# UNITED STATES PATENT AND TRADEMARK OFFICE

10/617,833

<b>Office Action Summary</b>	Application No. 10/617,833	Applicant(s) KIM ET AL.	
	Examiner James A. Menefee	Art Unit 2828

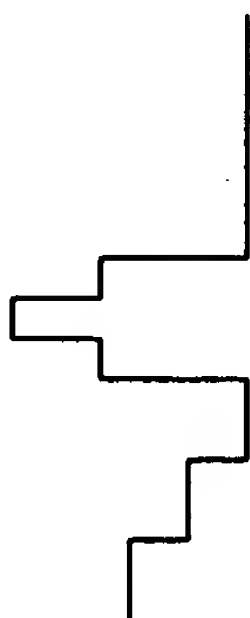
The drawings are objected to under 37 CFR 1.83(a). The drawings must show every feature of the invention specified in the claims. Therefore, the features of claim 16 must be shown or the feature(s) canceled from the claim(s). While the figures do show an embodiment with first second and third lower clad layers (Fig. 5), there is not shown in the figures such an

embodiment where the first lower clad (i.e. 59c) has a higher refractivity than the second (i.e. 59b). That is, a refractivity graph is needed similar to:

No new matter should be entered. Corrected drawing sheets in compliance with 37 CFR 1.121(d) are required in reply to the Office action to avoid abandonment of the application. Any amended replacement drawing sheet should include all of the figures appearing on the immediate prior version of the sheet, even if only one figure is being amended. The figure or figure number of an amended drawing should not be labeled as "amended." If a drawing figure is to be canceled, the appropriate figure must be removed from the replacement sheet, and where necessary, the remaining figures must be renumbered and appropriate changes made to the brief description of the several views of the drawings for consistency. Additional replacement sheets may be necessary to show the renumbering of the remaining figures. Each drawing sheet submitted after the filing date of an application must be labeled in the top margin as either "Replacement Sheet" or "New Sheet" pursuant to 37 CFR 1.121(d). If the changes are not accepted by the examiner, the applicant will be notified and informed of any required corrective action in the next Office action. The objection to the drawings will not be held in abeyance.
